DGM QA Approval and Discussion

**FORMER FORT ORD, CALIFORNIA
MRS 16
QUALITY ASSURANCE REPORT:
DIGITAL GEOPHYSICAL OPERATIONS**

**PREPARED BY
GEOLOGY SECTION
SACRAMENTO DISTRICT
U.S. ARMY CORPS OF ENGINEERS**

February 2009

Issue 1 – Grid C3A2I0

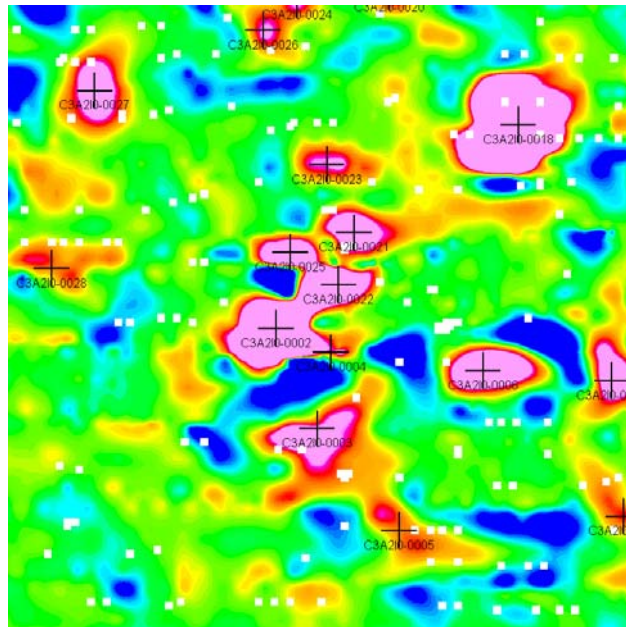
The anomaly cluster (anomalies 0002, 0022, and 0025) has a “latency like” appearance. It was discussed whether it was in fact latency or if it was a real configuration. It must be noted that the other anomalies in the grid do not exhibit the same issue (or it is extremely minor).

Response: All three anomalies (anomalies 0002, 0022, and 0025) were reacquired successfully and separately. The original picks and the required location were within inches for each separate anomaly. This grid was in the noisy area. Anomalies 0021 and 0023 were false positives. Therefore there was no latency issue regarding the anomalies in question.

Issue 3 – Upper lobe of anomaly C3A3D1-0008 should have been picked.

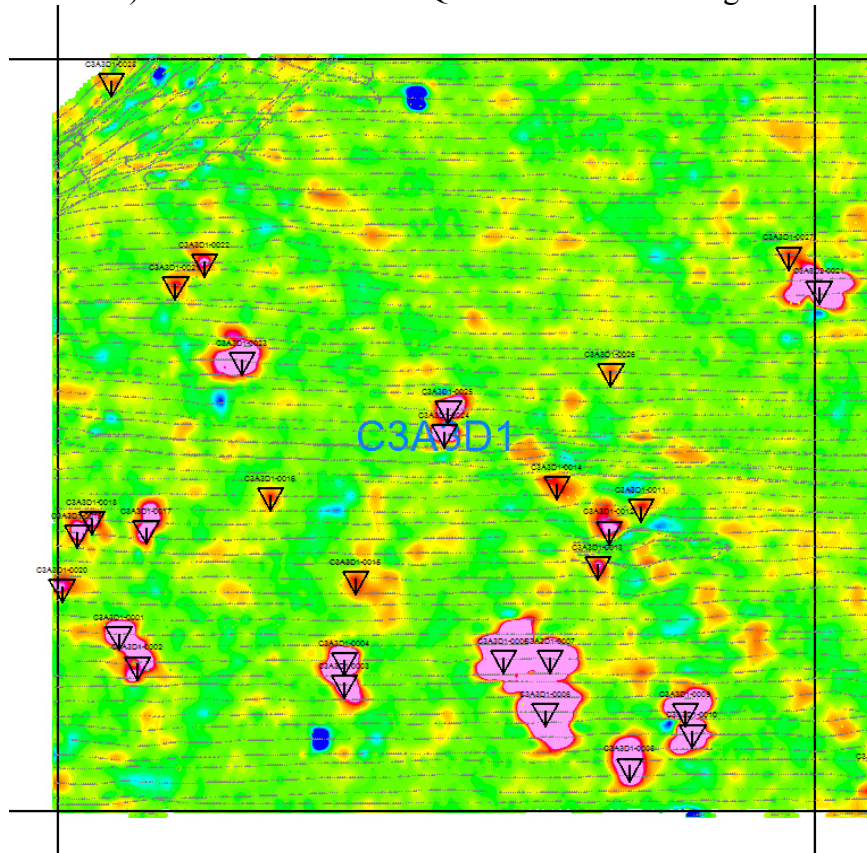
The upper lobe of anomaly C3A3D1-008 (southern part of grid) is 3 feet north of the anomaly pick and looks like it should have been picked as a possible separate anomaly. The solution for this scenario was straightforward. The C3A3D1-0008 anomaly was

actually reacquired 1.1 feet north of the shown pick (therefore the upper lobe was 1.9 feet north). The entire anomaly was excavated as per the 3 feet dig radius operation. The anomaly yielded 3 pieces of MDF (munition debris fragments) and 1 piece of RRD (range related debris). The excavation was QC'd with no remaining anomalies.

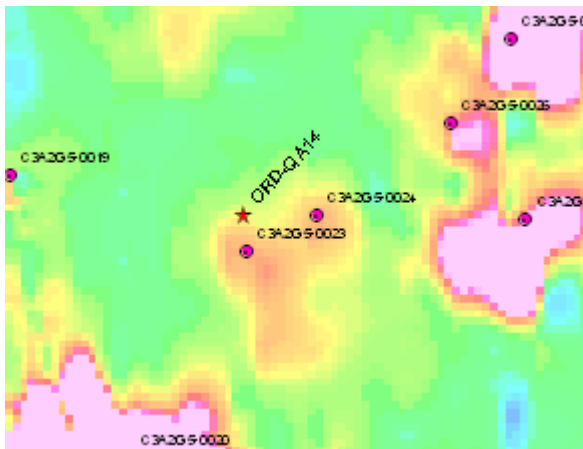
QA seed missed in grid C3A2G5 resulting in failure of grid block C3A2C5. Grid C3A2G5 is the only grid in the grid block that has been released to QA.

ORD-QA14 is a 37mm round buried vertically with a depth of 16-in. Anomaly pick C3A2G5-0023 is located approximately 1.3-ft from the seed and should have resulted in its recovery.

Although CAR 2 does not give coordinates of the QA seed we believe the QA seed is located in proximity to anomalies C3A2C5-0023 and C3A2C5-0024 shown in the CAR 2 map above. The location is shown under the star approximately 1.3 ft north of anomaly C3A2C5-0023. The EM61Mk2 response on reacquisition was 23 mV. This is above the pick threshold. This location was excavated and munitions debris removed. The excavation was then rechecked with EM61 Mk2. The EM61 Mk2 response was 0 mV. There are a number of possible causes for lack of recovery of this QA item as outlined below:

- 1) EM61 Mk2 check of excavation did not extend to 1.3 ft radius from excavation which would have resulted in detection of QA seed.
- 2) QA seed may have settled or been masked by munitions debris encountered nearby.
- 3) Malfunction of EM61 Mk2 resulting in false response of 0 mV.

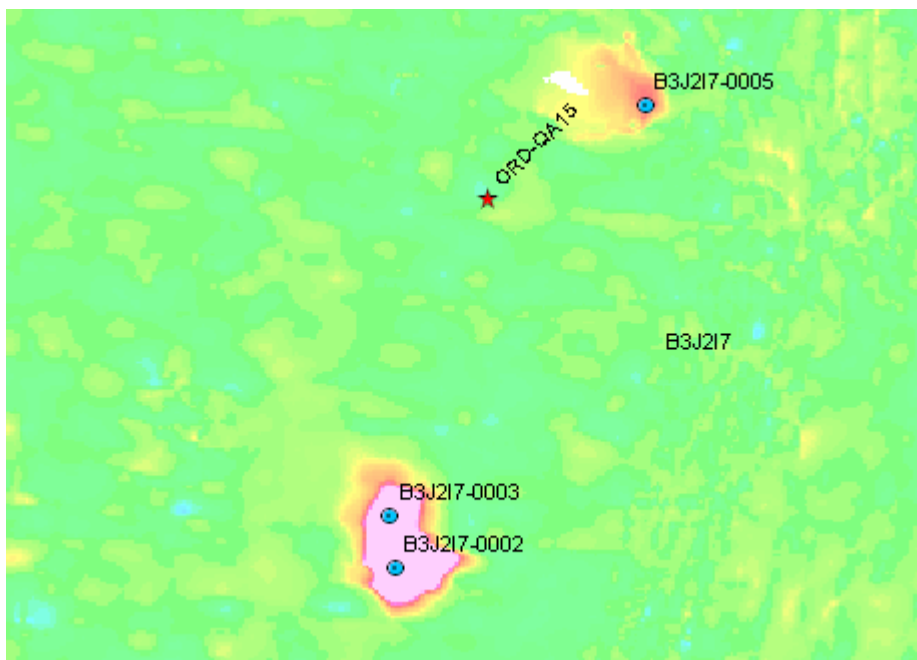
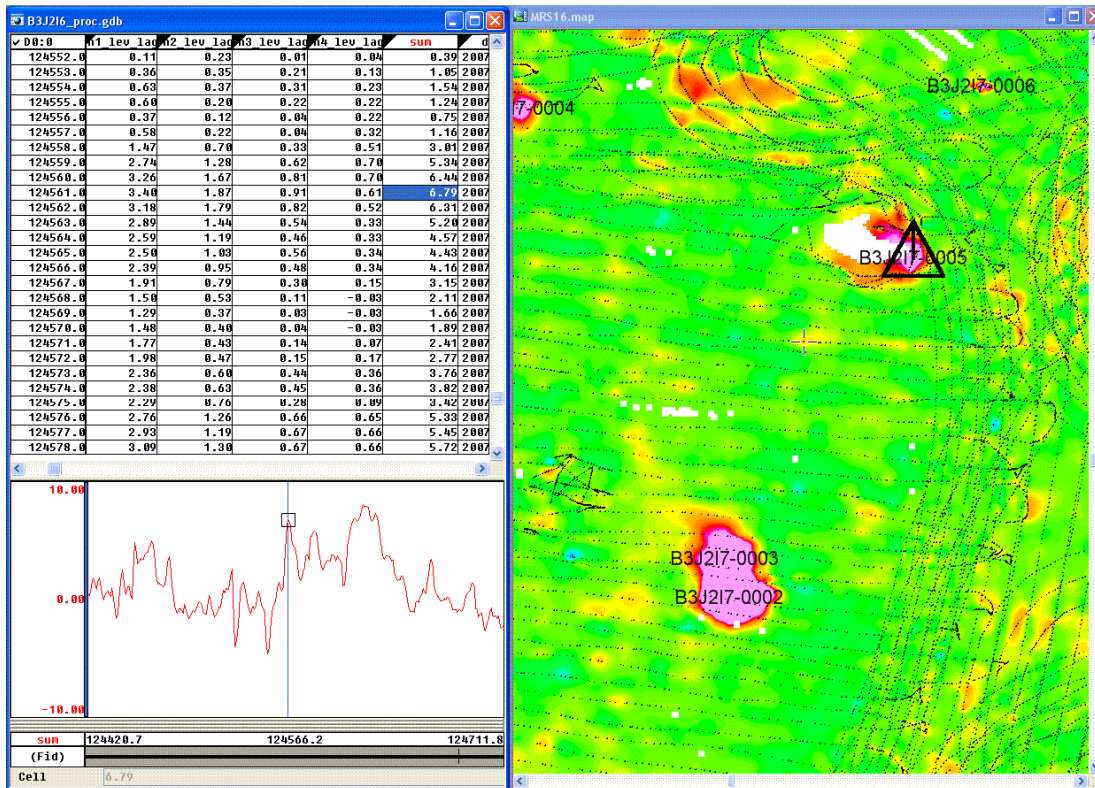
QA seed missed in grid B3J217 resulting in failure of grid block in which it was collected.

ORD-QA15 is a 37mm round buried vertically with a depth of 15-in. The nearest pick is B3J217-0005 located more than 10-ft to the northeast. Item was not detected by the DGM survey.

Although CAR 3 does not give coordinates of the QA seed we believe the QA seed is located as shown below in proximity to two other anomalies shown in the CAR 3 map above. The location is shown under the cross-hair point slightly more than 10 feet south west of anomaly B3J217-0005 in map below. The EM61Mk2 response is 6.79 mV. This is below the pick threshold. Since we have detected and picked all of the other QA seeds it is unlikely that the equipment couldn't detect this QA seed. Therefore the explanation is complex. Since the data and anomalies throughout the rest of the grid are acceptable and consistent we don't believe there was an equipment malfunction. The tracking data also show good coverage. It may be possible that the QA seed settled or has been shifted by animal activity.

It would be recommended that we bring a single new EM61 Mk2 system to see if the QA seed is detectable at the project threshold. If it is not detectable then the depth of the seed needs to be examined. We also need to confirm the exact location of the QA seed item by getting the coordinates.

CORRECTIVE ACTION REQUEST | NO. :CESPK-ED-GG-FY08-006

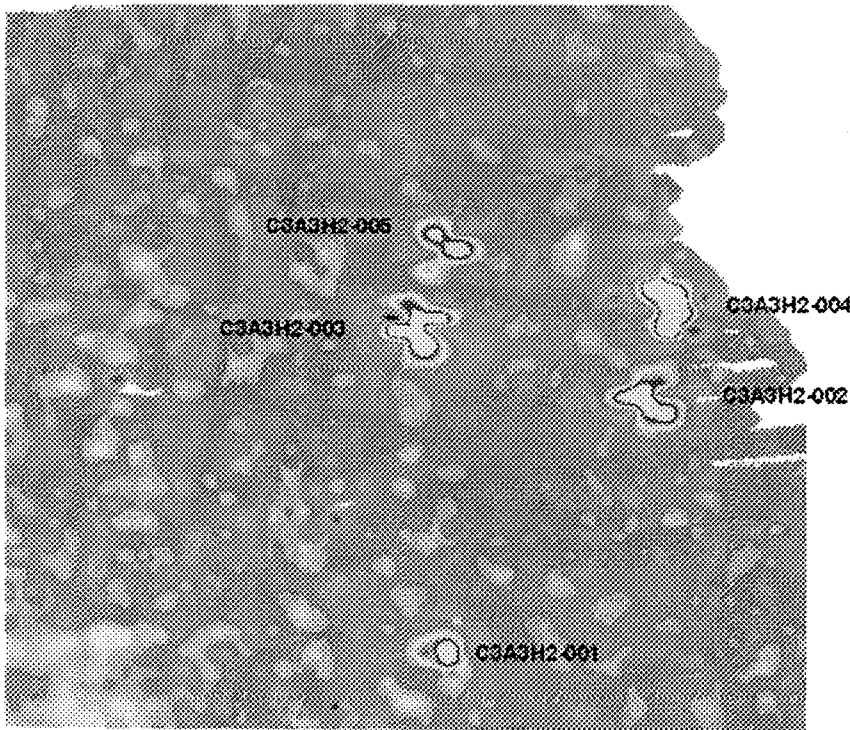
Grid block C3A3H2. 5 anomalies above pick thresholds were identified following QA digital surveys. Dig results found:

Status: QA grid failure

After plotting the locations of the anomalies detected in the QA mapping of grid C3A3H3 Shaw noticed that there were no anomalies for 4 out of the five locations indicated in the QA data (anomalies 2,3,4, and 5 - see above figure). Anomaly 1 is located in a cluster of anomalies and may represent one of the anomalies. We also noticed that all of the anomaly locations, when shifted 10.5 feet to the northwest, fall on top of one of the mapped anomalies. Many times anomaly clusters displaced by the same amount are caused by GPS problems (ergo: one cause can be lack of correction to position from a base station). This caused Shaw to look at the GPS in detail.

Shaw has done extensive research into this particular problem and has found the cause. The data were collected on 3/21/07. To start with the USACE protocol, and Fort Ord MRS-16 Geophysics QC Plan, requires that daily quality control (QC) of GPS data be implemented by taking a daily GPS reading against a known survey monument in the morning before fieldwork to verify that the GPS is working (static navigational test). The standard is that the reading has to be within 2.0 feet of the known survey location. On the morning of 3/21/07 the morning GPS reading was within 0.32 feet of the known survey location. In addition a daily "dynamic navigational test" is conducted by placing a hitch ball on an existing grid corner (surveyed) within the area to be surveyed that day. The dynamic navigational test indicated that the hitch ball was 0.10 feet from the grid corner on 3/21/07. Additional checks were also executed by looking at the GPS data during afternoon calibration tests for sensor drift and lag correction.

GPS Track-lines showing area where Grid C3A3H3 was affected.

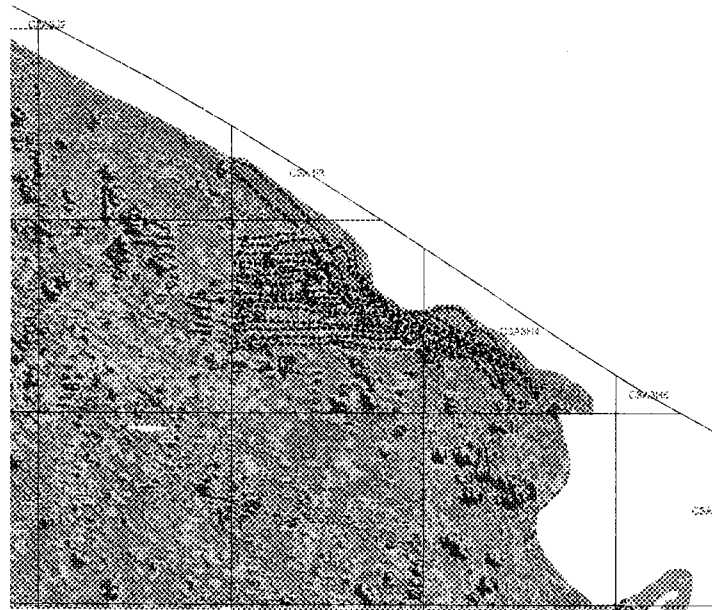
Shaw's next step was to go back and check ALL of the data collected at MRS-16. After checking all of the data from MRS-16 only one other, much smaller area, was affected (in Grid C3A3C5). Both affected areas are shown in the graphic below.

The next step that Shaw conducted was to extract the raw GPS files (before it enters MagLog) to determine if GPS lock quality can be extracted from the raw files. Raw GPS files do have an indicator of GPS lock quality. Each data point has an associated number (from 1 to 4). Number 1 indicates that the RTK GPS is "out of lock" and represents an uncorrected (no RTK) GPS location. Numbers 2 through 4 indicate that RTK GPS is "in lock" with increasing accuracy (even a 2 is within standards). Numbers 2 through 4 represent corrected GPS locations (RTK is working). Shaw then wrote a program to examine the raw GPS files for the numbers associated with the lock accuracy of a given raw GPS file. Shaw found that the data on 3/21/07 had some number 1 (out of lock) data. Approximately 1/16th of the data collected that day was affected by loss of lock. That area affected also correlates directly with the area where the anomalies were found during the QA inspection.

Grid block C3A1E0. 1 anomaly above pick threshold identified following QA digital surveys. Dig results found:

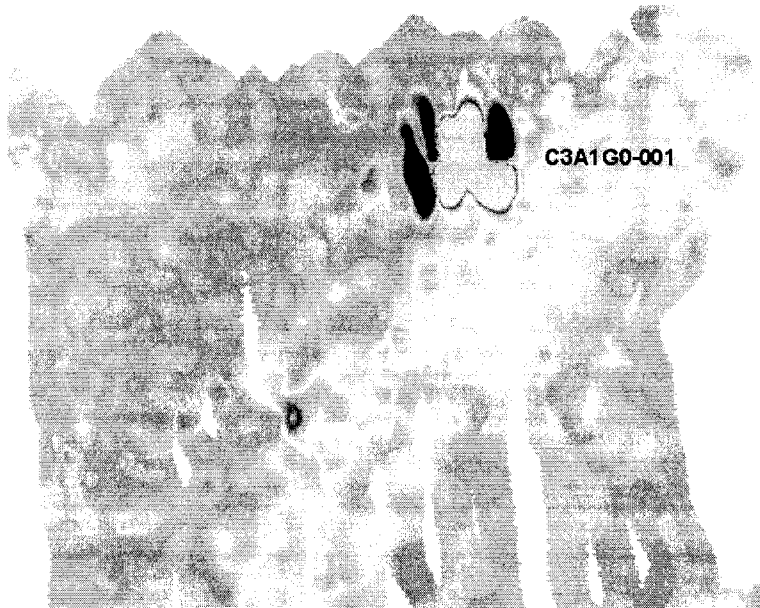
Status: QA grid failure

Action Taken to Correct Condition: (Corrective Action should address root cause, not the symptom).
None.
